**COUNTY OF SAN MATEO
PLANNING AND BUILDING DEPARTMENT**

SUBJECT: EXECUTIVE SUMMARY: Consideration of an appeal of the Coastside Design Review Committee's decision to approve a Design Review Permit and Grading Permit pursuant to Section 6565.3 of the County Zoning Regulations and Section 9283 of the County Ordinance Code, for the construction of a new 2,771 sq. ft. two-story single-family residence, with an attached 507 sq. ft. two car garage, 330 cubic yards of grading and no tree removal, on a vacant 5,230 sq. ft. parcel, located between 631 and 647 El Granada Boulevard , in the unincorporated El Granada area of San Mateo County.

County File Number: PLN 2019-00162 (Love/Zheng)

SUBJECT: Consideration of an appeal of the Community Development Director's decision to approve a Design Review Permit and Grading Permit, pursuant to Section 6565.3 of the County Zoning Regulations and Section 9283 of the County Ordinance Code, for the construction of a new 2,771 sq. ft. two-story single-family residence, including an attached 507 sq. ft. two-car garage, 330 cubic yards of grading and no tree removal, on a vacant 5,230 sq. ft. parcel, located between 631 and 647 El Granada Boulevard, in

SHEET:
A3.01
OF SHEETS

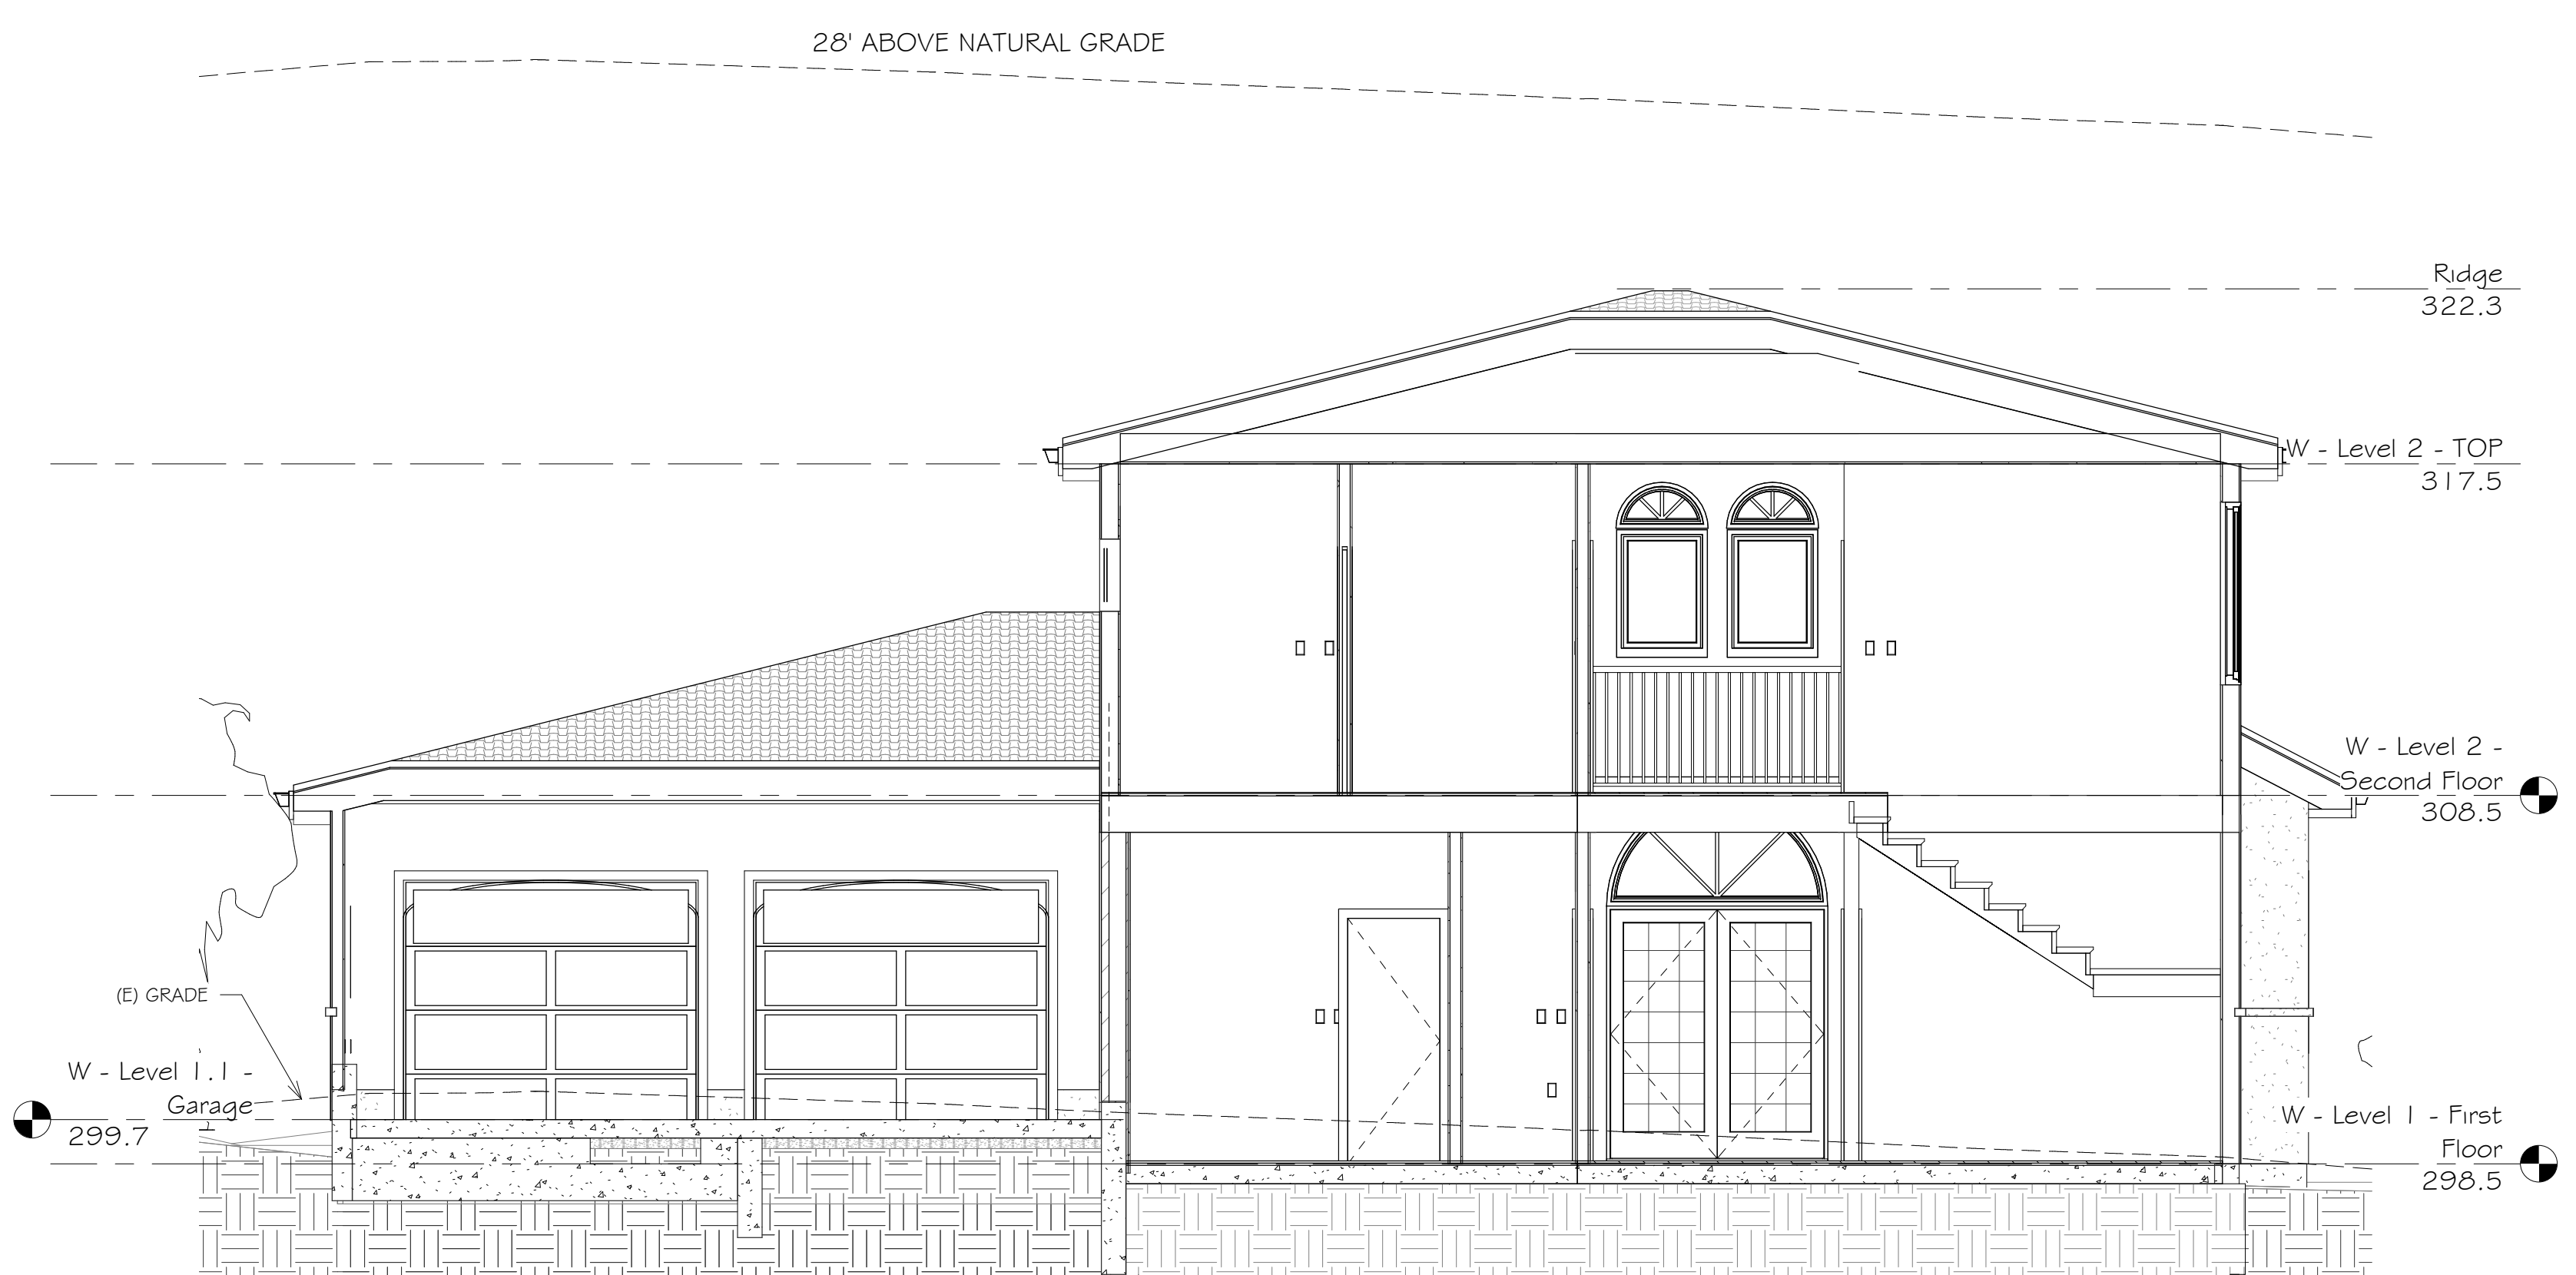
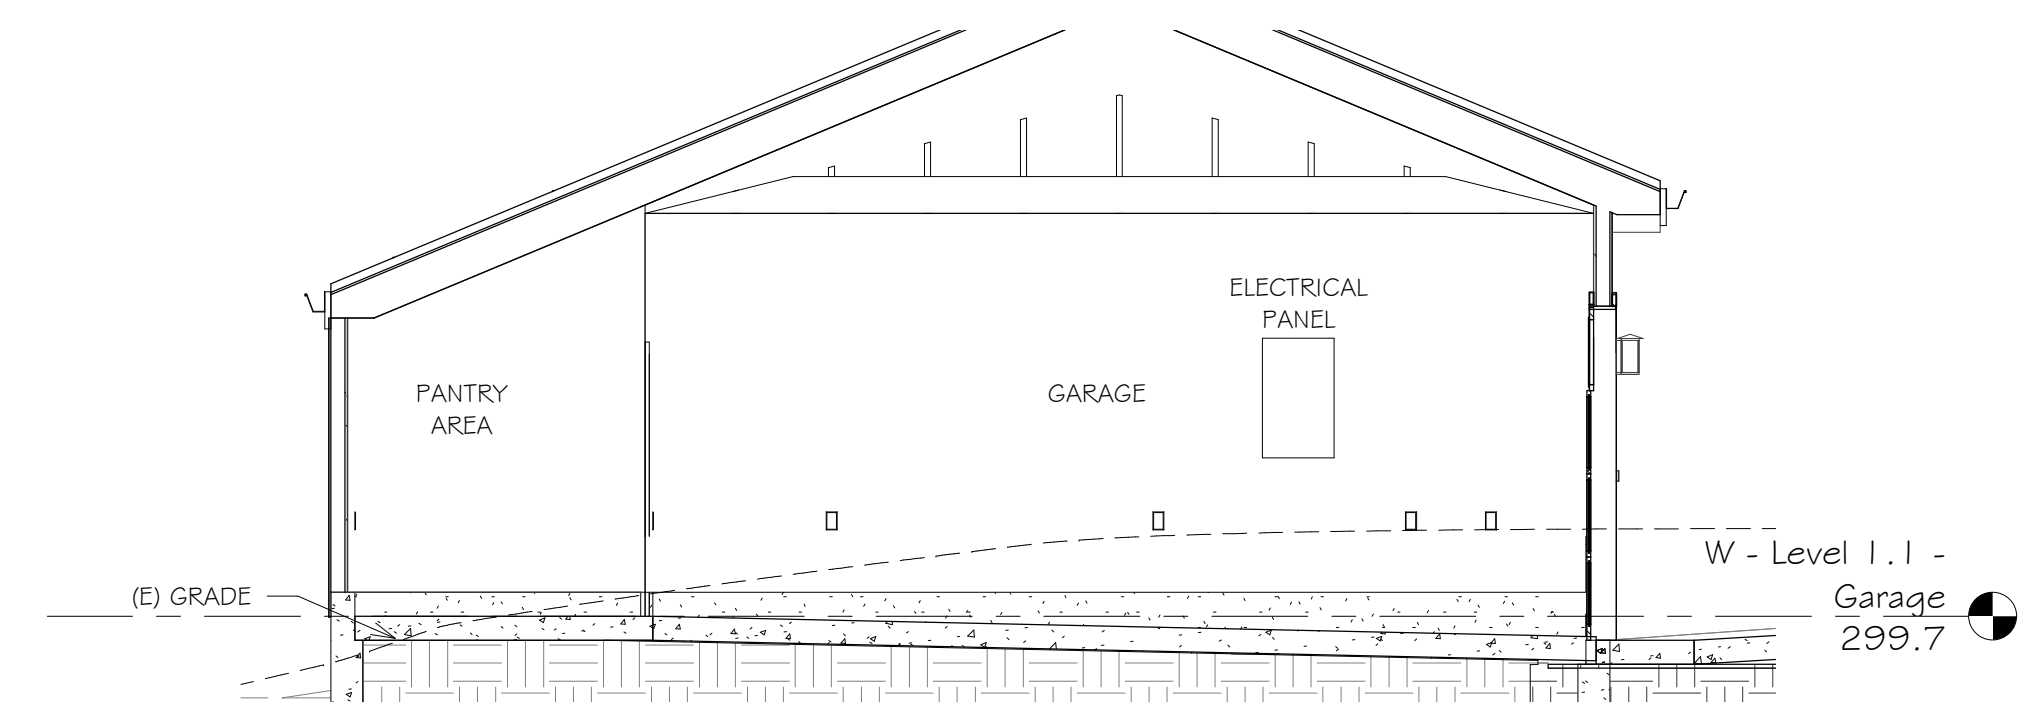
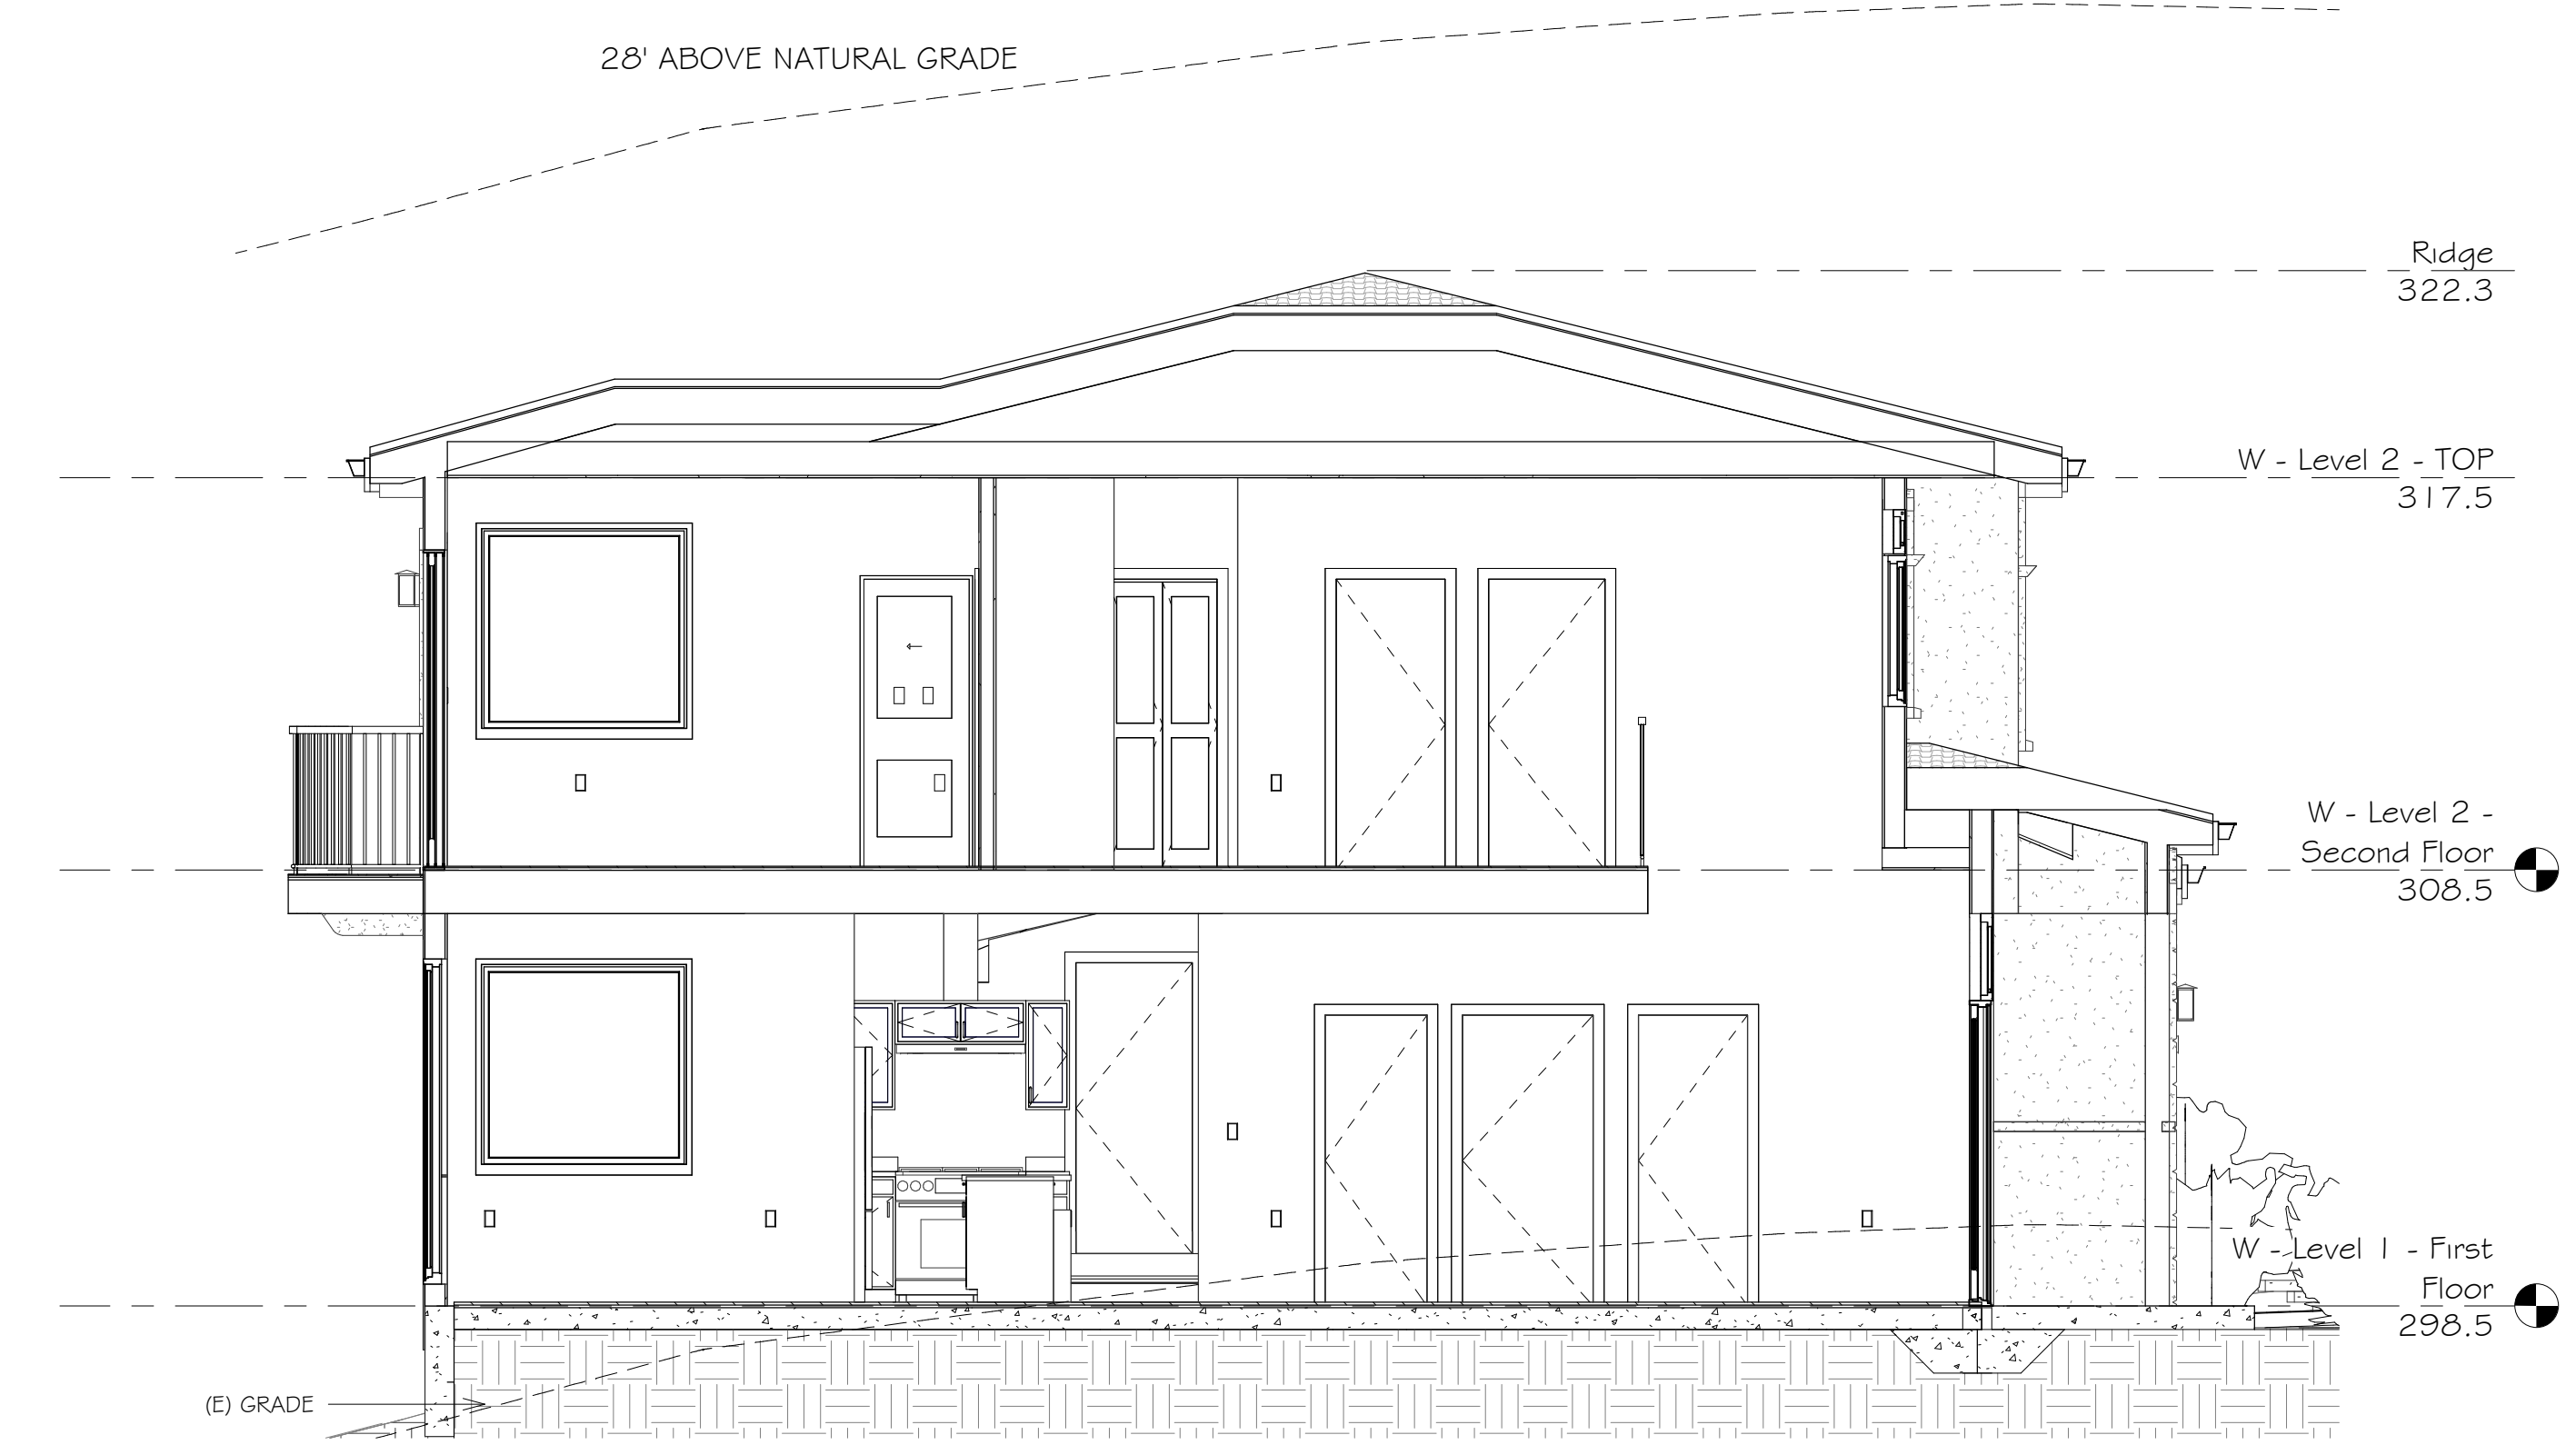
For page A3.01, Section A1 and A2, I have sketched what I am asking for ("Front to back cross section" and "side cross section"). The existing grade needs to be added to each cross section. This is how staff verifies the height.
